Your Ref
BN/9/14/
Our Ref
PLAN-005810
Date
09/04/2014

Proposal: Conversion of existing garage/hobbies room outbuilding to elderly relative/guest accommodation.

Site: Holmwood, Park Road, Barnham, PO22 0AQ.
BN/9/14/

Screen Print

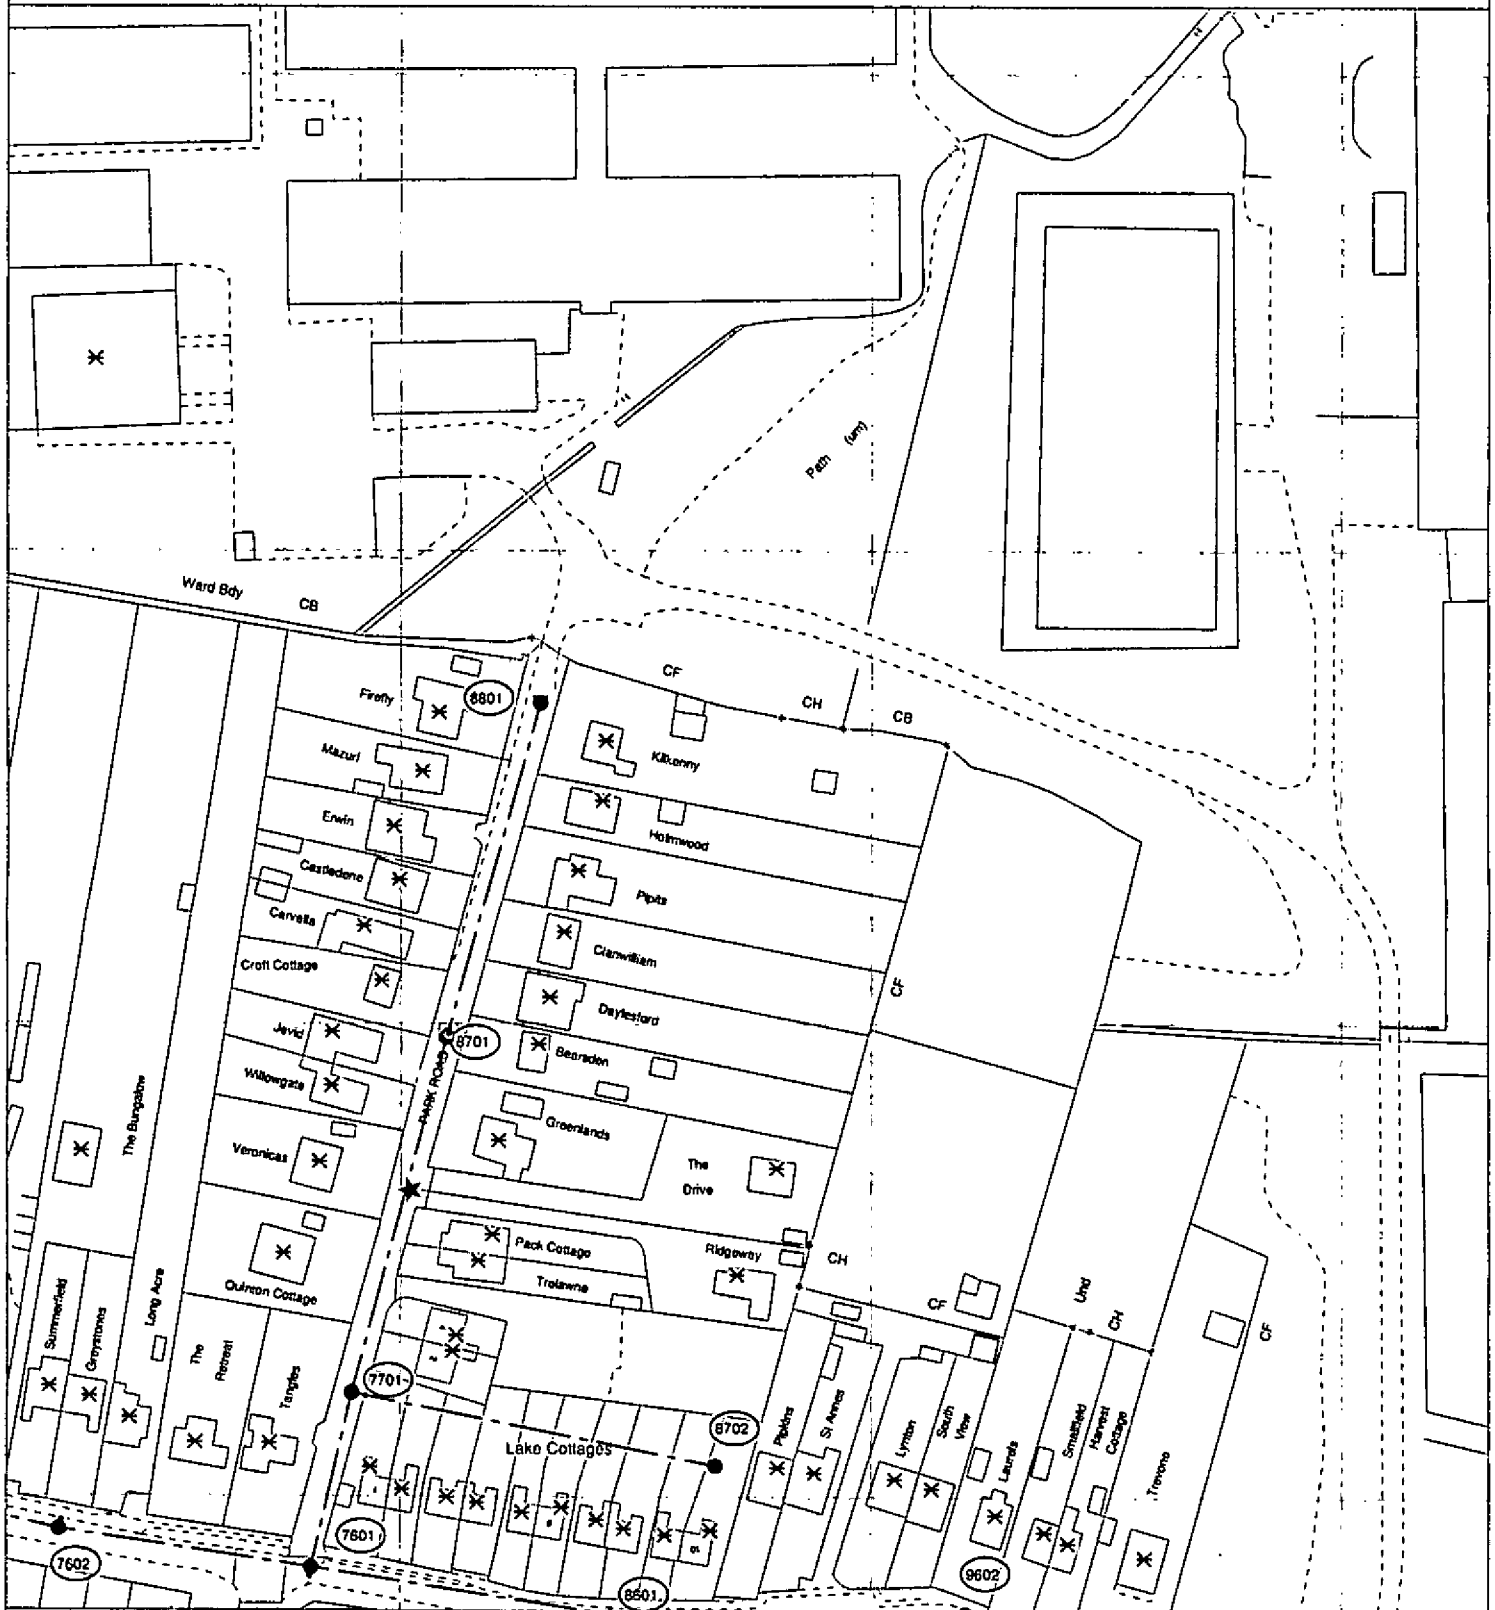
Our initial investigations indicate that there are no public surface water sewers in the area to serve this development. Alternative means of draining surface water from this development are required. This should not involve disposal to a public foul sewer.

Due to changes in legislation that came in to force on 1st October 2011 regarding the future ownership of sewers it is possible that a sewer now deemed to be public could be crossing the above property. Therefore, should any sewer be found during construction works, an investigation of the sewer will be required to ascertain its condition, the number of properties served, and potential means of access before any further works commence on site.

The applicant is advised to discuss the matter further with Southern Water, Southern House, Sparrowgrove, Otterbourne, Hampshire SO21 2SW [REDACTED] or [REDACTED]
